LAND USE APPLICATION SUMMARY

Property Location: 1300 West Lake St., 1300 ½ West Lake St. and 2928 Fremont Ave. South
Project Name: 1300 West Lake Street
Prepared By: Aaron Hanauer, City Planner, (612) 673-2494
Applicant: Daniel Oberpriller, CPM Development, LLC
Project Contact: Bob Loken of ESG Architects, Inc.
Request: To build a seven-story mixed use building with residential units, office space, and commercial space.

Conditional Use Permit	To allow for increase in the maximum height from 4 stories, 56 feet to 7 stories, approximately 91.6 feet at tallest point in the C3A/Community Activity Center District.
Variance	To increase maximum allowable floor area from 3.8 to 4.3.
Variance	To increase the size of a commercial storefront from 8,000 square feet to 21,700 square feet in the C3A/Community Activity Center District.
Variance	To reduce the interior setback from 17 feet to 0 feet to allow the building and port cochere.
Variance	To increase the distance the first floor will be located from the front property lines in the Pedestrian Oriented Overlay District from 8 feet to 15 feet (from Fremont Avenue) and 29 feet (from Lagoon Avenue).
Variance	To reduce the off-street loading r

1 PAVING AND GEOMETRIC PLAN
 C4.0 1" = 20'

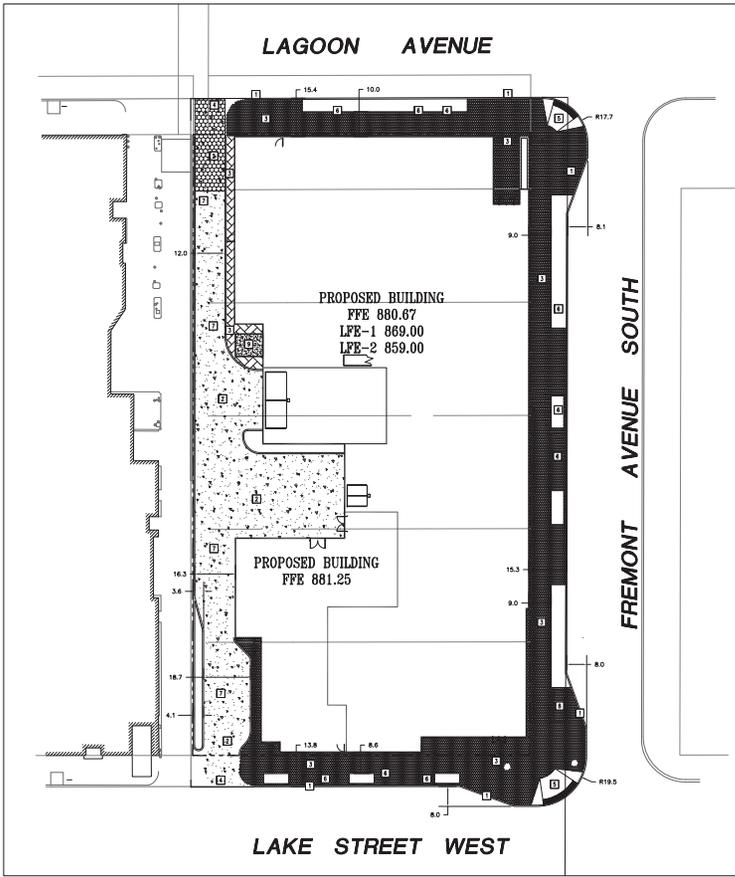
- <http://www.minneapolismn.gov/publicworks/transplan/index.htm>
- The symbolism for proposed sidewalk depicted on Sheet C4.0 of the plans would seem to indicate a distinctive joint pattern that is different from the sidewalk pattern depicted on the Landscaping Plans (Sheet L1.1); the Applicant shall clarify the proposed sidewalk joint pattern and depict it consistently throughout the plans. Note that minimum joint spacing of 4' is typical for Minneapolis standard sidewalk.
